Comments relating to this OBC.

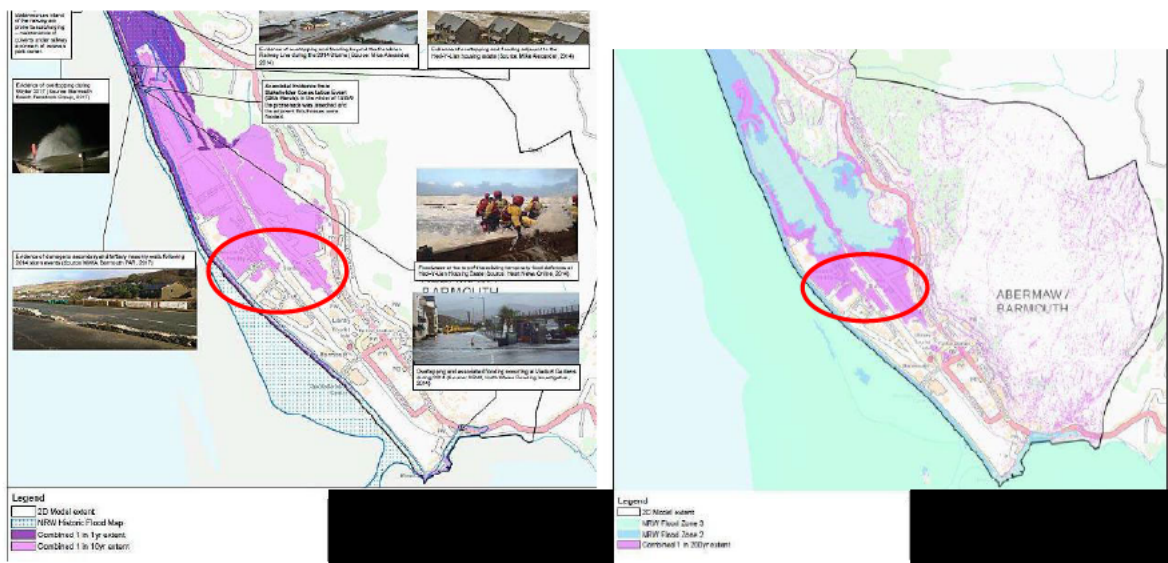
- Appendix B – validation (Figure 17 and 18). The model result shows a significant area of flooding near the intersection of Park Road and Bryn Mynach Road in the modelled 1 in 10 (Figure 17) that is not shown in NRW's zone 2 and 3, which represent significantly larger events (Figure 18) (See below Figure). I appreciate that this is a validation exercise not a verification exercise but is there a known reason for this difference?
